Matanuska-Susitna Borough LiDAR & Imagery Project Quality Assurance Report Matanuska Block V2

Written by Rick Guritz

Alaska Satellite Facility

March 28, 2013

Figure 51, Moose Creek Double Breakline Drainage missing lines.

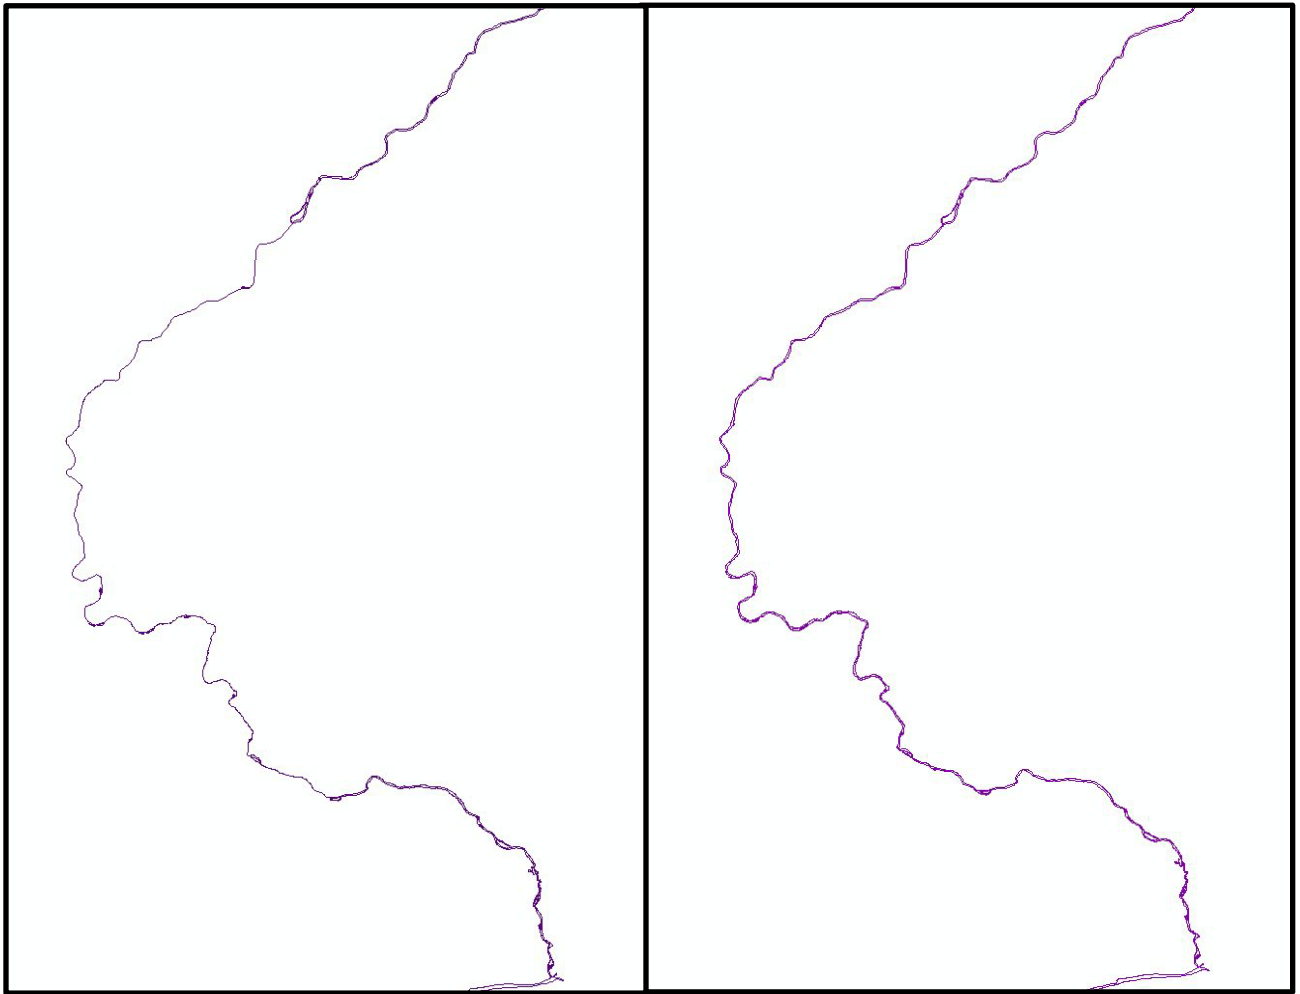
UAF reported missing shorelines of Moose Creek in double line drainages – On 7/10/2012, UAF reported issues with the double break line drainages. In particular, Moose Creek was missing one of its shorelines (see Figure 51).

Delivery 3 – On 7/10/2012, Aerometric staged hydro break lines on their FTP site.

Figure 52, Seams and artifacts in shaded relief of first return DSM (MAT_025 and MAT_035).

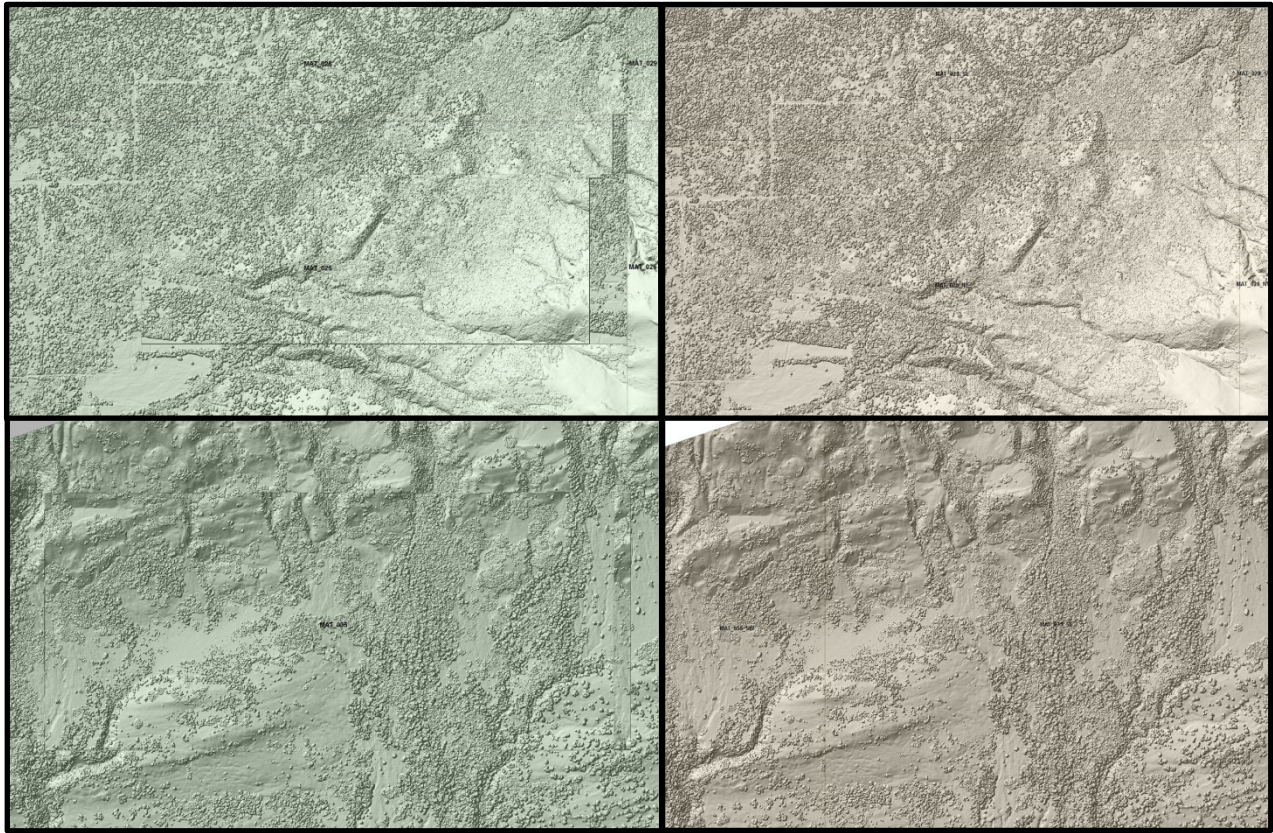
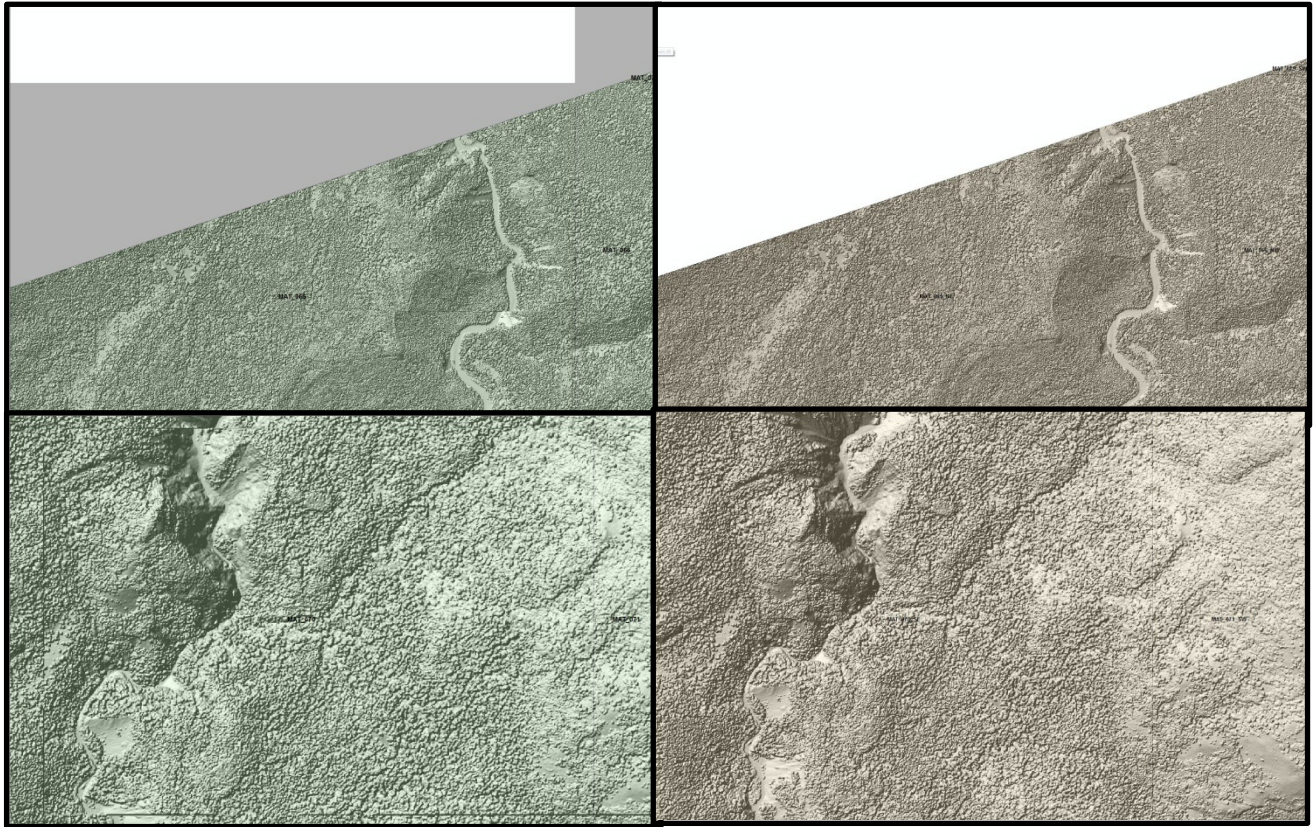
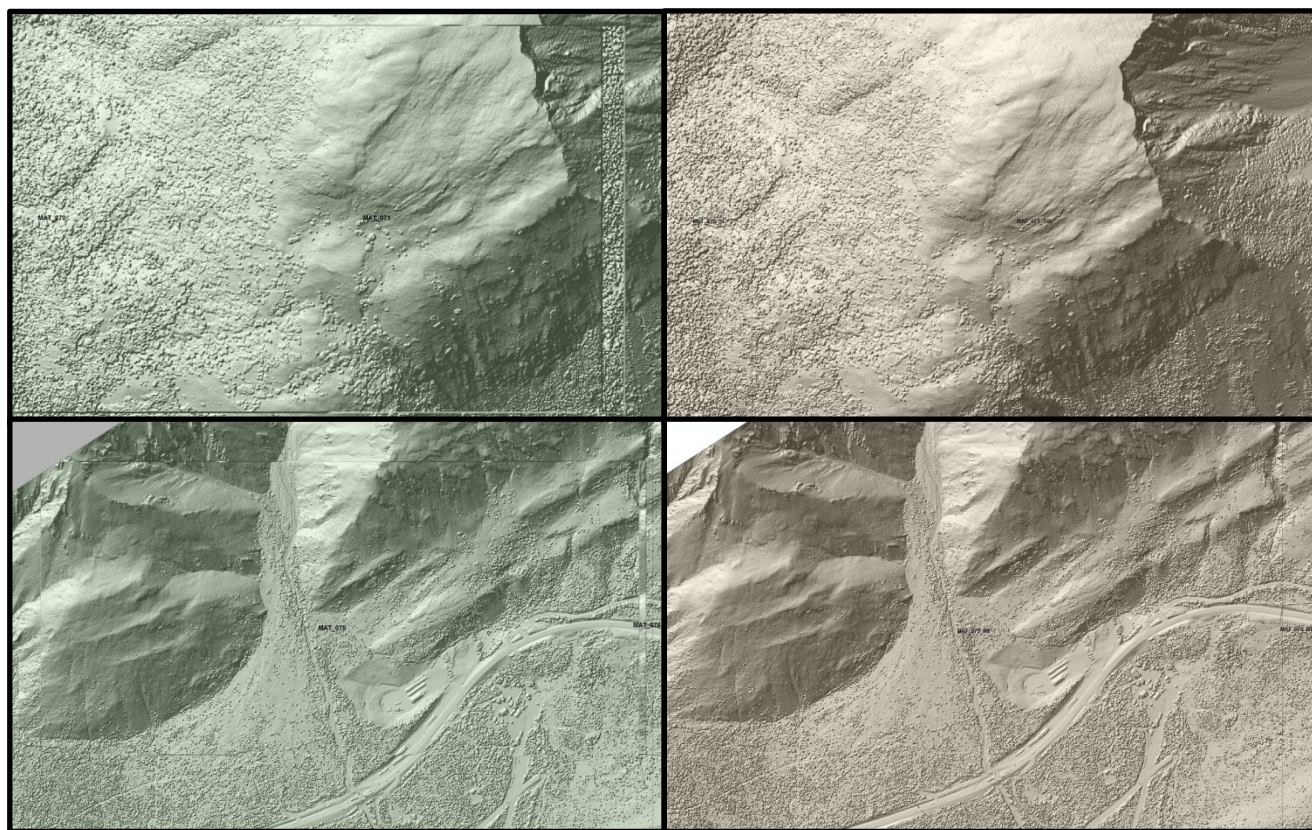
UAF reported seams and artifacts in first return DSM – On 7/10/2012, UAF reported problems with the first return DSM. There were visible seams and discontinuities that looked like shifts in the data. Seven regions were identified as problem areas documented in screen captures (see Figures 52-55). Tiles affected include: MAT_025, MAT_035, MAT_065, MAT_070, MAT_071, MAT_075, and MAT_076.

Delivery 5 – On 7/23/2012, Aerometric delivered to UAF a disk containing corrected DSM's for Matanuska block.

Figure 56, Cross calibration swaths removed from unclassified class 1 LAS point cloud data.

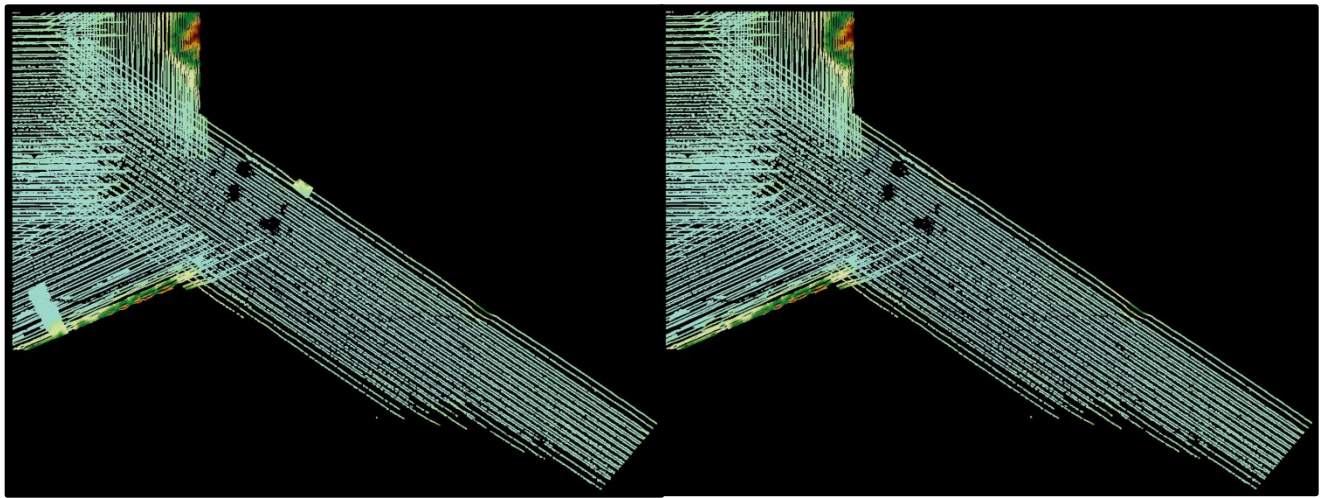
UAF reported results of LAS point cloud assessment – On 7/27/2012, UAF reported (1) cross calibration swaths that need to be removed from unclassified class 1 (see Figure 56), (2) low veg class 3 still contains points over water, (3) medium and high veg class should also be checked, (4) power transmission lines class 11 has discontinuous power lines (see Figure 57). UAF requested that these data quality issues be investigated.

Delivery 7 – On 7/29/2012, Aerometric staged 7 corrected LAS point cloud tiles, in which cross calibration swaths were removed or water classifications were improved, on their FTP site.

Figure 58, Six missing quarter tiles in LiDAR Intensity data.

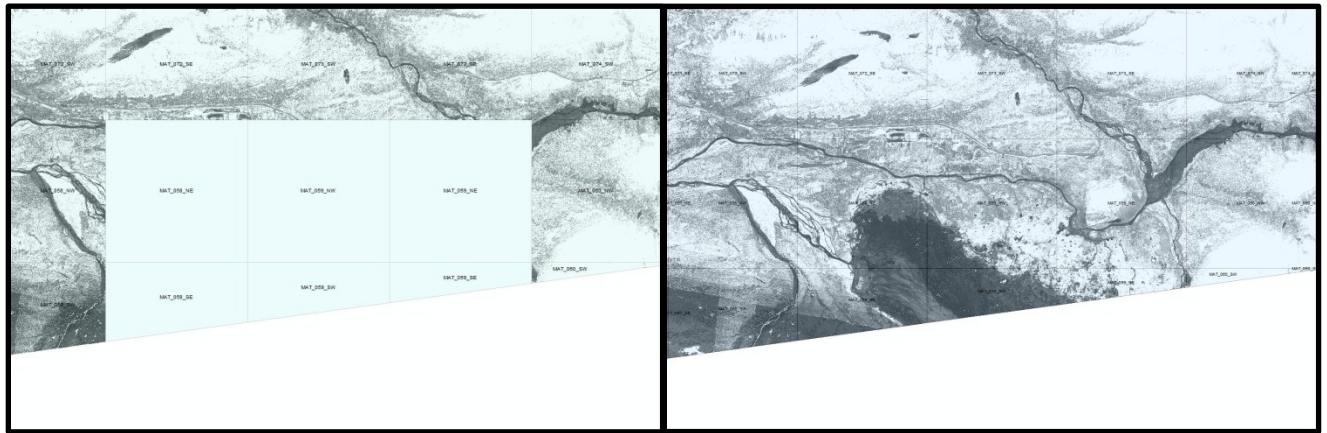
UAF reported six missing LiDAR intensity tiles – On 8/6/2012, UAF reported a section of missing LiDAR intensity data mosaic (see Figure 58). This was identified as six missing quarter tiles that were not included in the delivery.

Delivery 9 – On 8/8/2012, Aerometric staged 6 corrected LiDAR intensity tiles for Matanuska block on their FTP site.

Figure 59, Negative heights detected in canopy height estimate when subtracting bare-Earth DEM from First-Return DSM (tiles: MAT_053 and MAT_074).

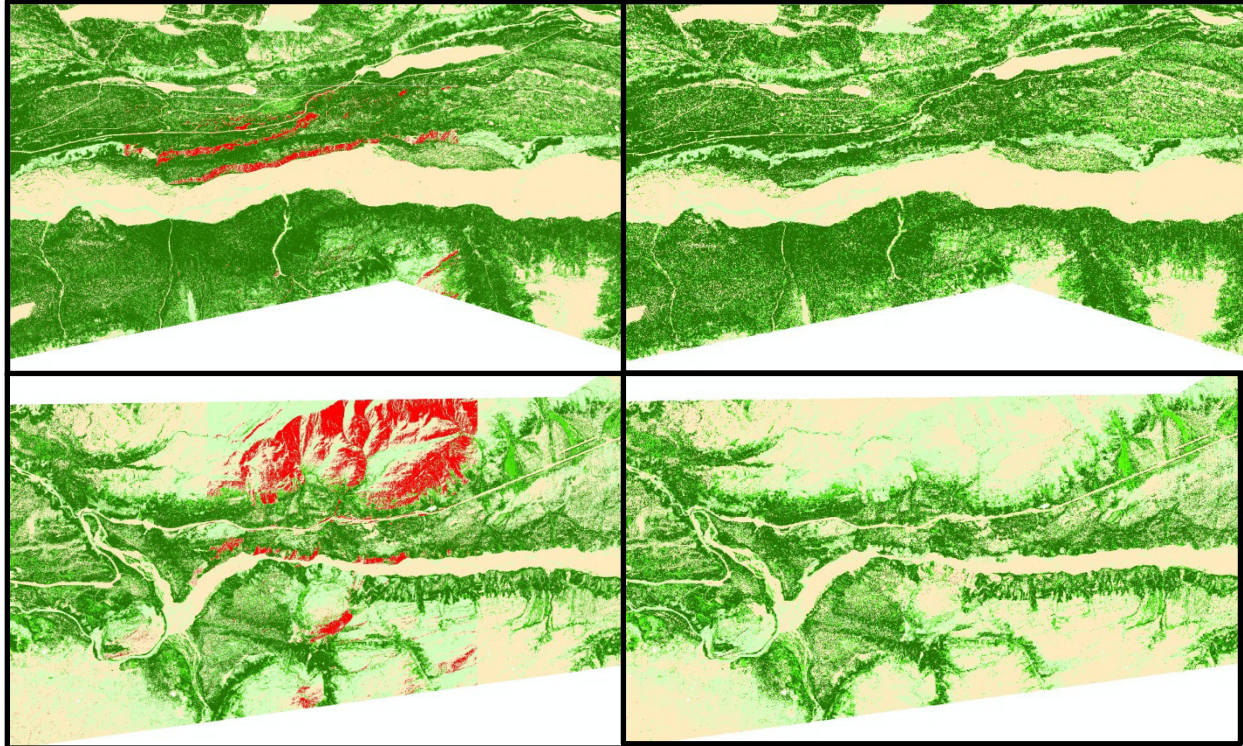
UAF reported negative heights in canopy height estimate – On 3/21/2013, UAF reported negative values in the canopy height estimate product. This test showed that some areas had a bare-Earth DEM that was higher than the first-return DSM (see Figure 59).

Delivery 12 – Aerometric delivered to UAF a delivery disk on 03/25/2013 containing a redelivery for Talkeetna and Matanuska blocks which addressed the negative canopy height estimates. This was later identified as a resampling issue due to work flow inconsistencies.
